**TOWN OF HERNDON, VIRGINIA
ARCHITECTURAL REVIEW BOARD WORK SESSION AGENDA
MAY 4, 2022
HERNDON MUNICIPAL CENTER
LARGE CONFERENCE ROOM, 2nd Floor
777 LYNN STREET
7:30 P.M.**

2. **APPLICATION FOR BUILDING ALTERATION, ARB #22-001**, to consider an application for alteration to an existing structure located at 1201 Elden Street, Herndon Virginia, further identified as Fairfax County Tax Map 0161 02 0016D1 and located in the southeast quadrant of the Elden Street and Herndon Parkway intersection. This property is zoned CS (Commercial Services) and consists of 38,754 square feet of land. Owner: Chevy Chase Bank FSB. Applicant/Agent: Alan Su.

Title: ARB #22-001; Building alteration; 1201 Elden Street

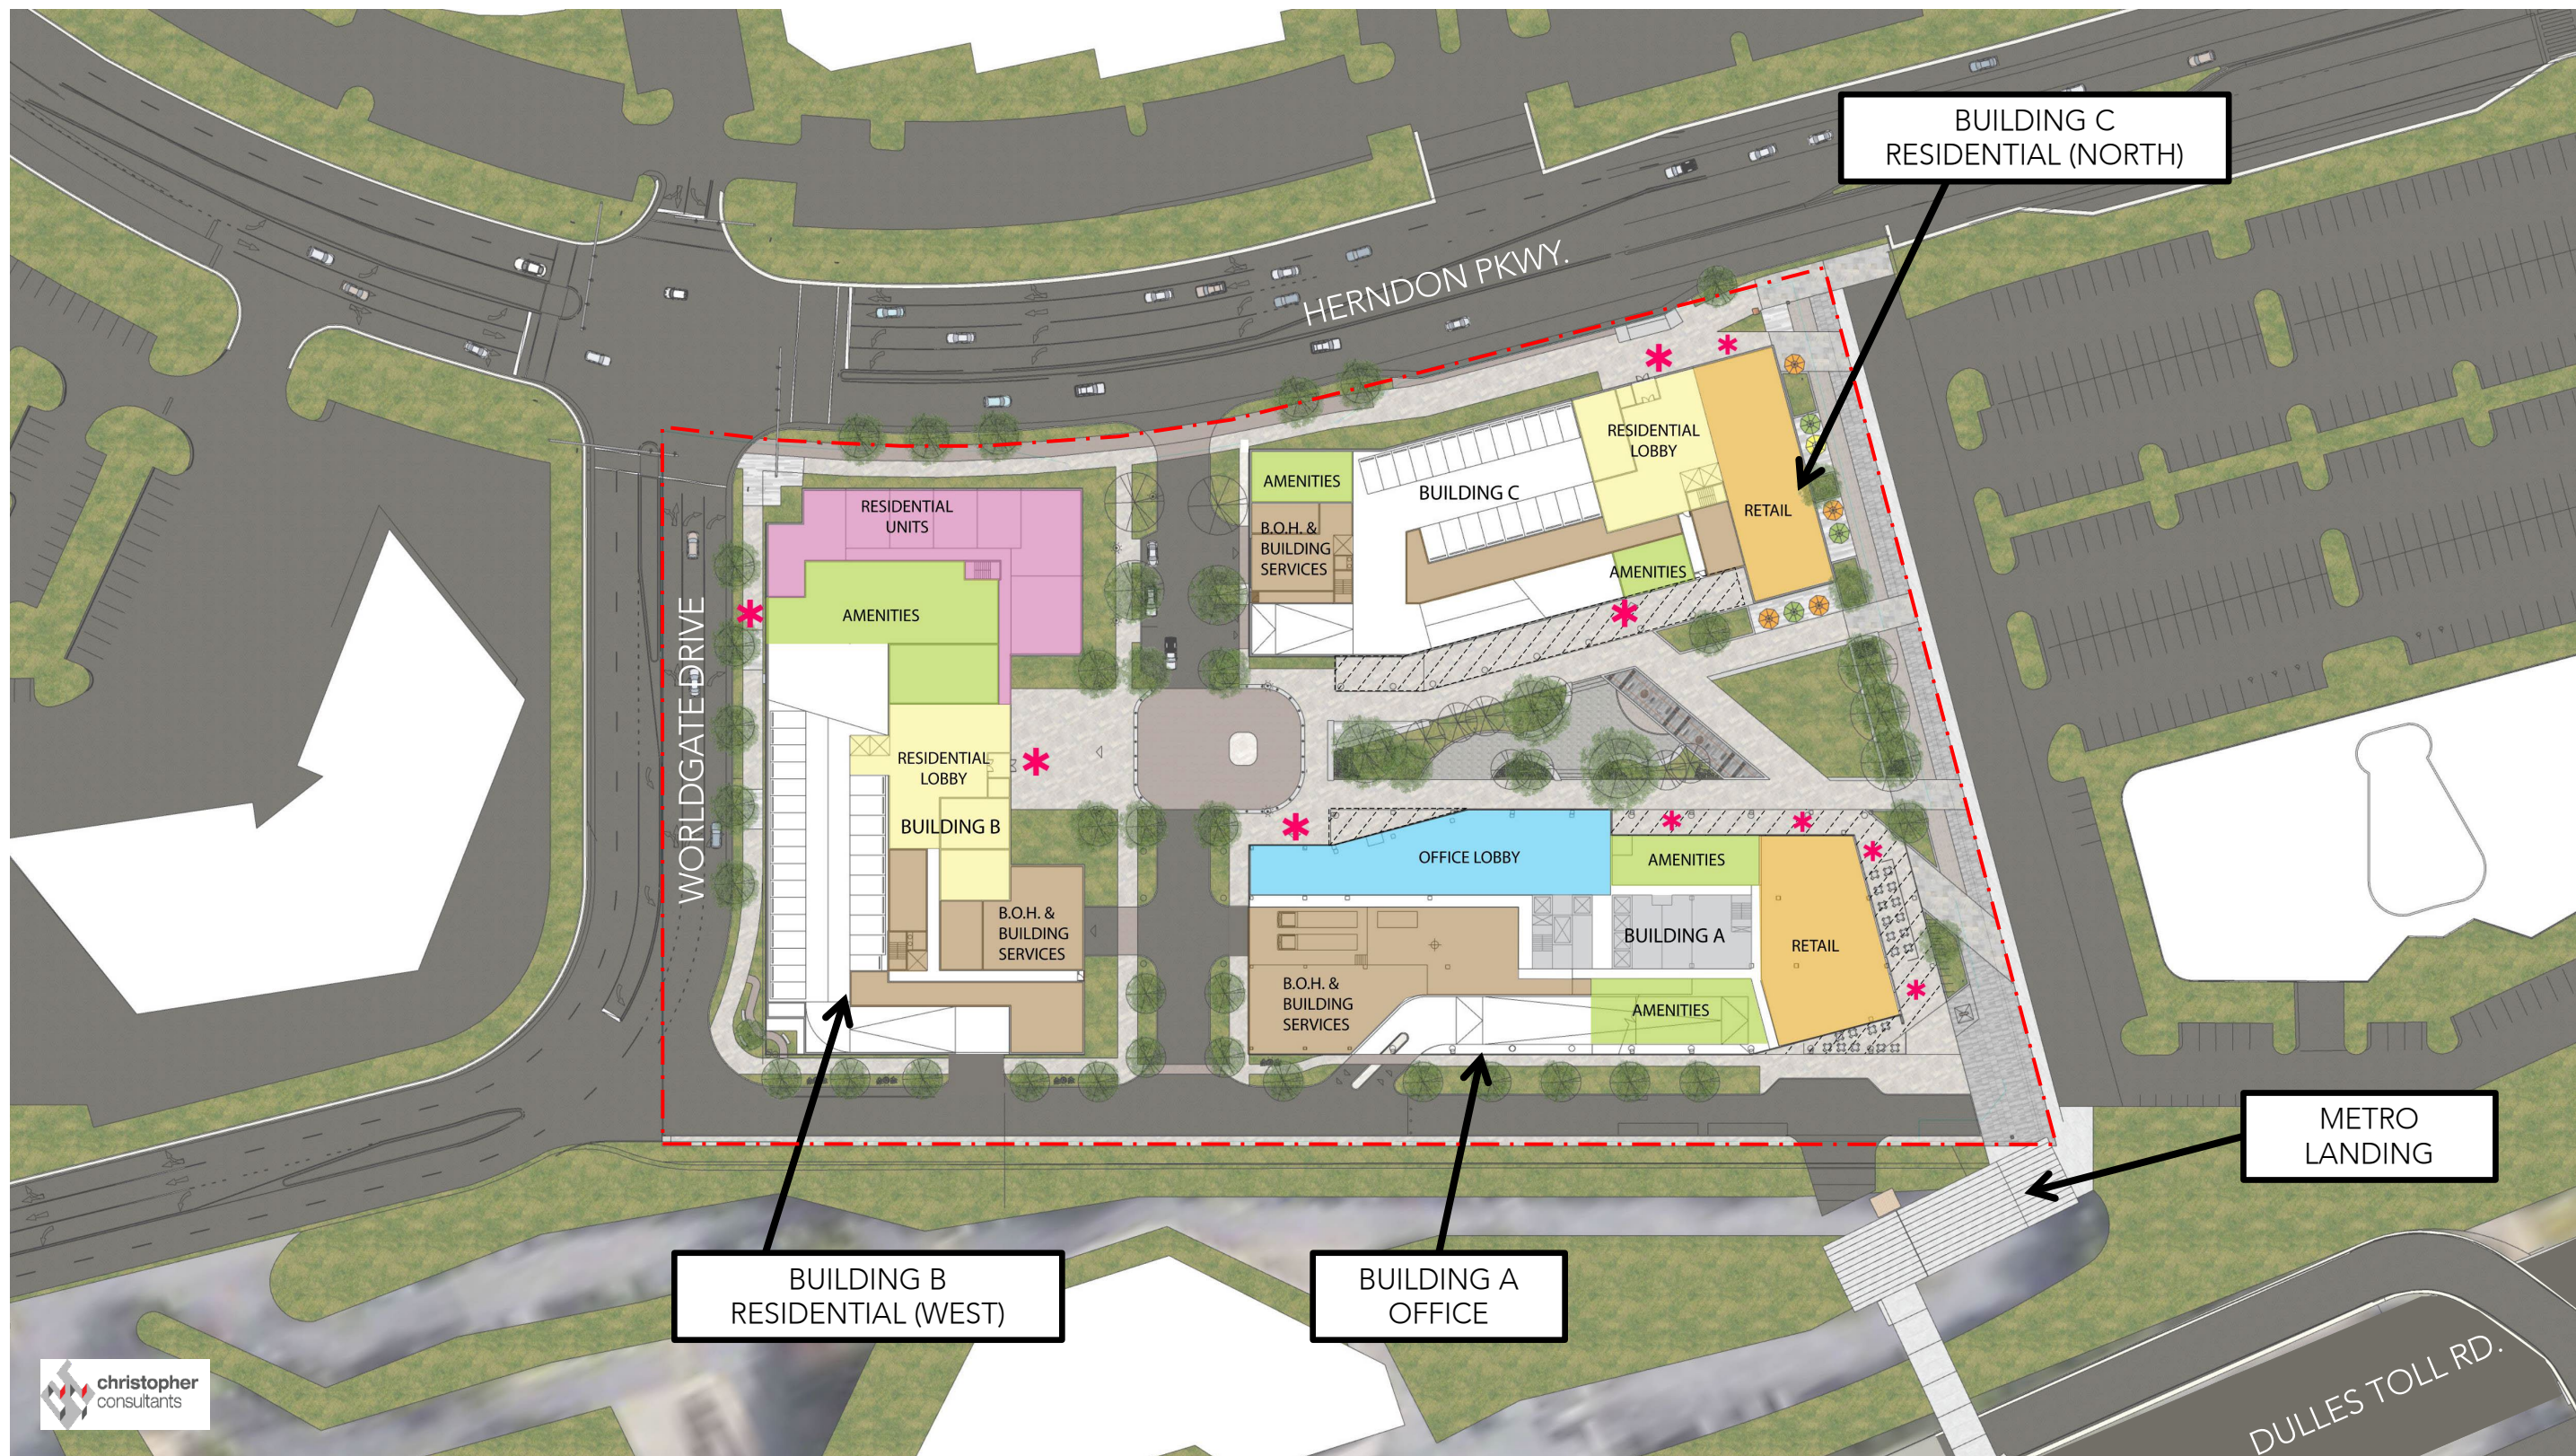
into a unique and pedestrian friendly area. In addition to this, the architectural feature can be seen throughout the DC Metro area or other urban centers with a purpose and setting wholly different than Herndon's. Staff still suggest modifications could be made to the columns to more fully adhere to the Guidelines and the purpose of this area. For example, using a combination of materials on the bulk of the column to soften appearance or a flared capitol at the top of the columns to integrate more smoothly with the garage base.

The recessed balconies provide vertical emphasis and a needed break from an otherwise flat façade. Staff suggests that the use of color to articulate the façade further may be too heavily relied upon. Using color and variation can be an important tool in increasing architectural variation, but staff suggest that a more thoughtful arrangement of color and perhaps a more limited pallet could be more successful in this case. Using a single material color/type for one elevation section divided on either side by the balcony recesses could be an option.

“framing”. Both changes were made to help reduce the overall mass of the garage facades, which staff believes did help in that regard. The right-angle voids in the perforated metal screening however look arbitrary and tend to detract from the overall aesthetic rather than add articulation. The open garage directly adjacent to the Metro pavilion is a particular concern. Exactly where those breaks occur should be discussed further during the formal ARB review of the architecture.

As with buildings B and C, the architectural treatments and materials at pedestrian levels should receive close care. The lower-level façade design at the southwest corner of the south elevation and along the length of the drive to the Worldgate Drive extension needs additional attention in regards to detail and material. This façade will be readily visible from the Metro pavilion and southern portion of the Promenade. Furthermore, pedestrians will travel its length to reach the Worldgate Drive extension. Eventually the private street along this façade will become the primary access for redevelopment that occurs to the south and most likely will be across from the front façade of those future buildings. Staff recommends that additional attention to the design of this façade is needed.
